Construction Division
Additions & Alteration Charges Approval Form

GULMOHAR RESIDENCY

Details of Additions & Alterations

Flat No	Block no.	Type	Deluxe / Luxury
H-502		1360 sq ft	
Buyer Name Mr. Surya Raja. G			
Phone No. 8861154855			
Email gsd-gjaredy@gmail.com

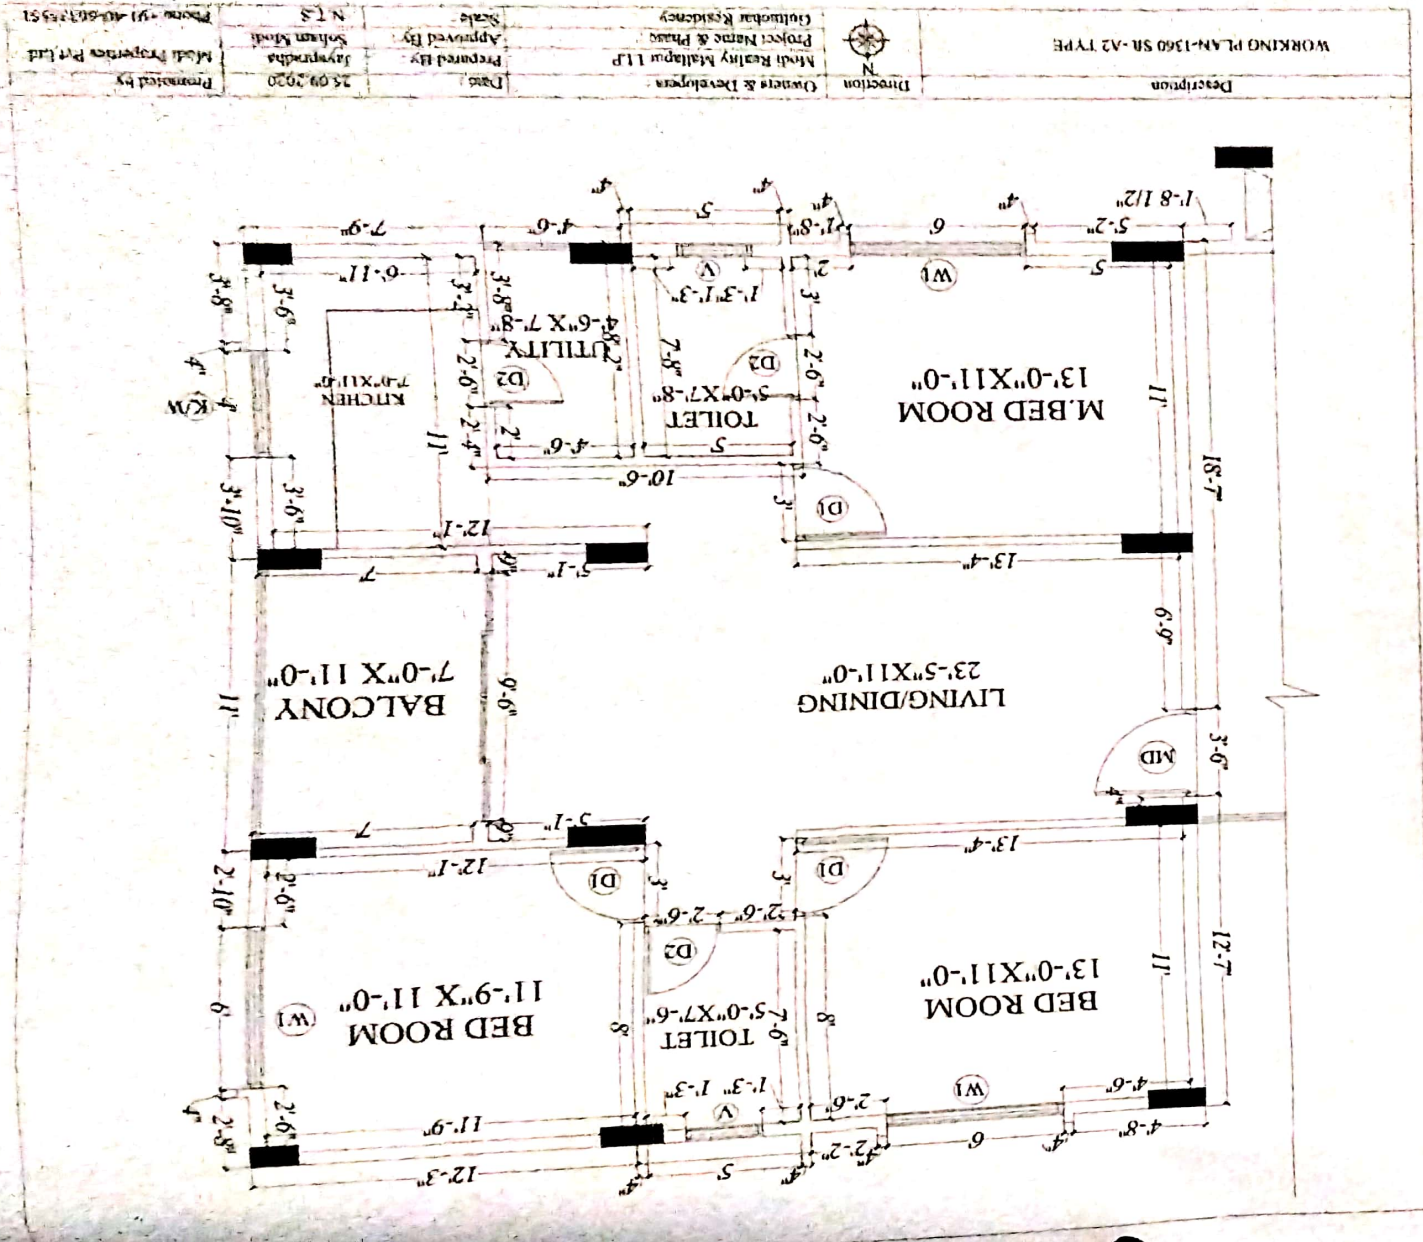
Changes in flooring:

① Abt. 28-104 mado. Abt.

Choice of Bathroom tiles, CP fittings & Sanitary ware:

(1) MT/CT - Ultra Sprinkle tile. ✓

(2) MT/CT - (CP Sink (extra basin) should be given by Customer) ~~MT/CT~~

Changes in kitchen platform (mark on plan)

Q Kitchen - 8 ft (Conting Passio & Conting chachelle)

Clicker dado files customers scope

Other Changes

① Bakery - Gift (Crusty Almond) ✓

③ 3rd room - Arabin, Mahaguy. ✓

④ Hall & Lindy - Gottschling Estate. b

Description		Direction	Owners & Developers :		Date :
PLUMBING PLAN-1360 Sft (A2-TYPE)		N	Modi Realty Mallapur LLP		16.09.20
Project Name & Phase		Approved By :	Submittal Mark :		NTS
Gulmohar Residency		Prepared By :	Model Preparation Period :		Prepared For :

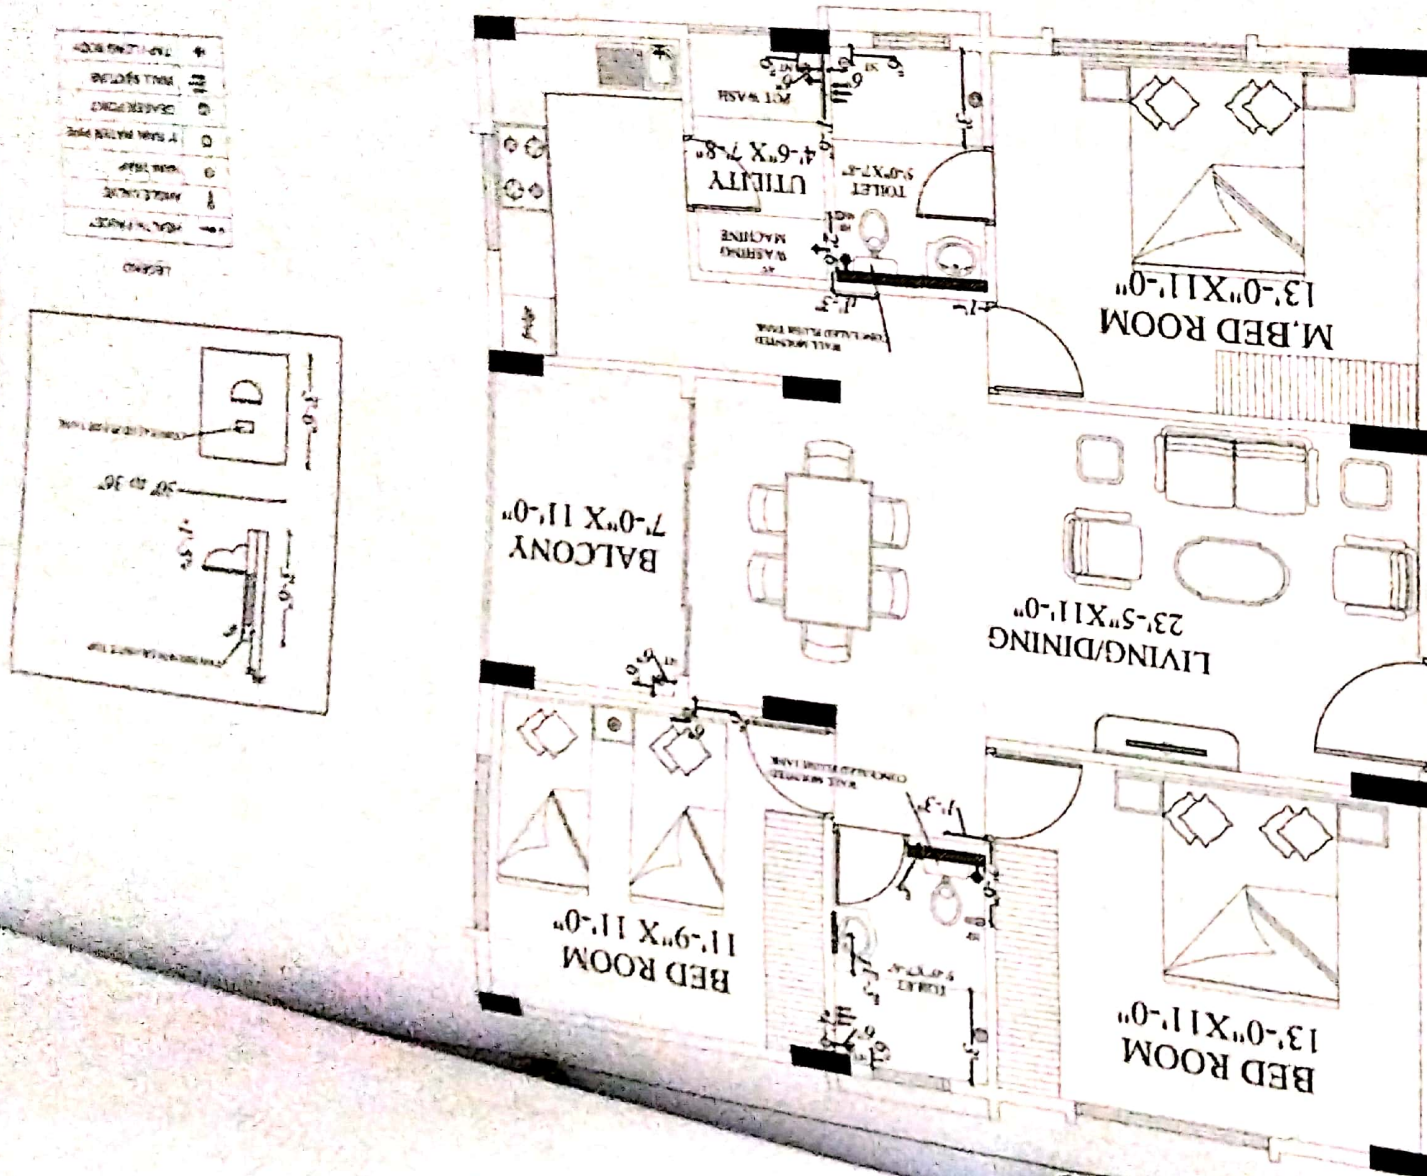
Changes in electrical points: (mark on plan)

Description		Direction		Owners & Developers : Date : 21.09.2020 Prepared By : Jayaprasada Approved By : Soham Mohi Project Name & Phase : Model Realty Mallapur LLP Scale : N.T.S. Phone: +91-40-66335531
ELECTRICAL PLAN - 1360 sft FLATS-A2 TYPE

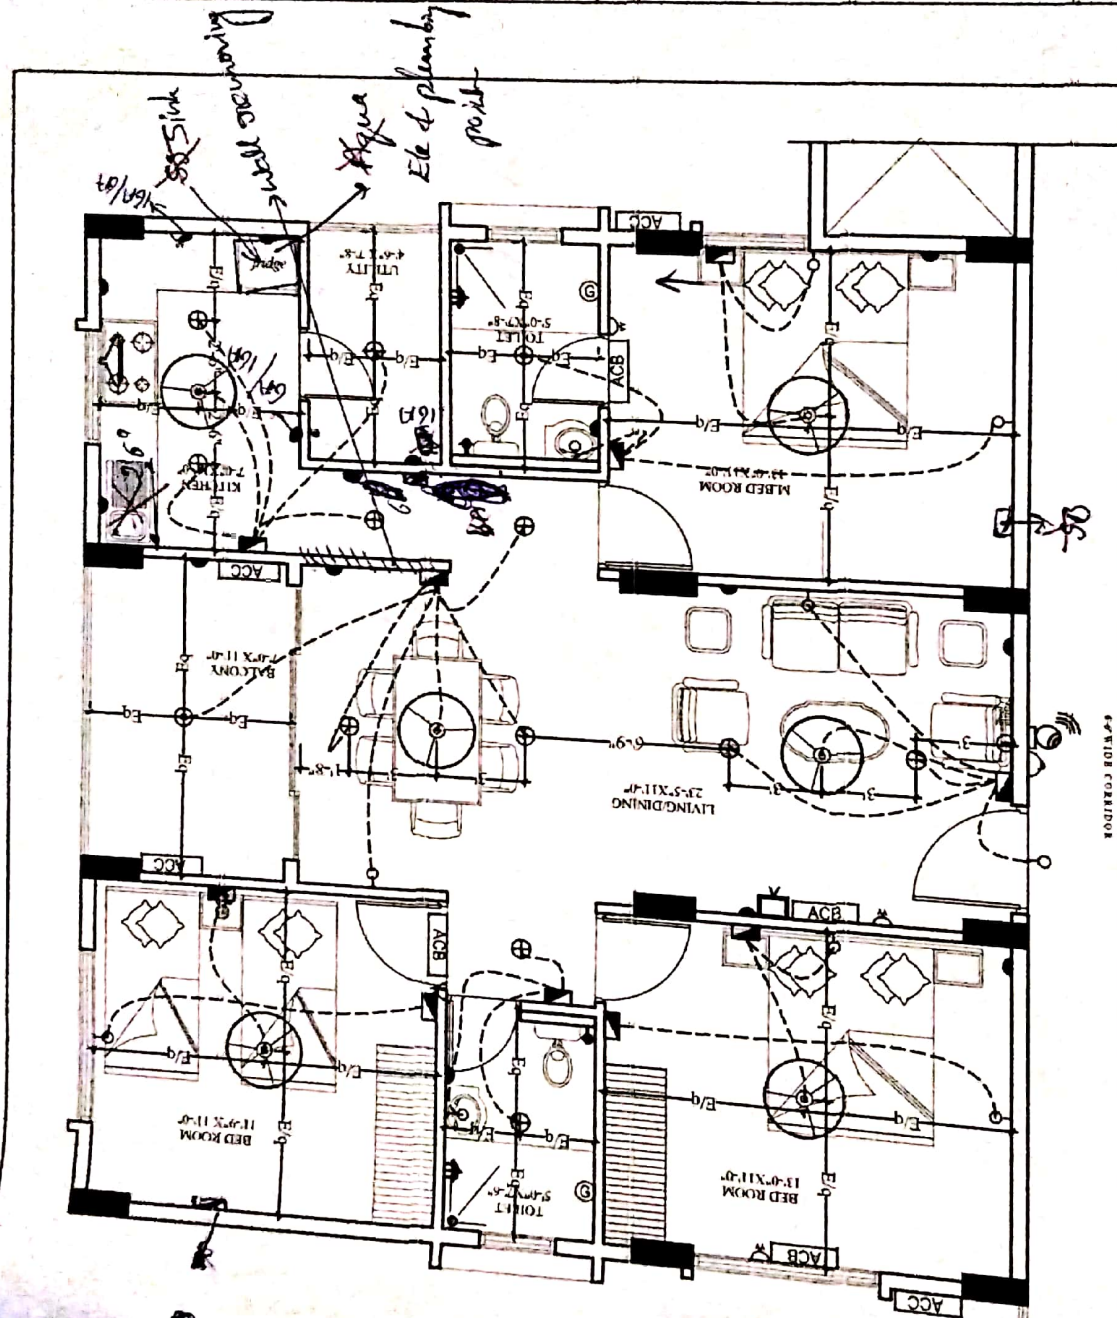
Note - Switch boards next to bed side must be @ 36" from corner of bed.
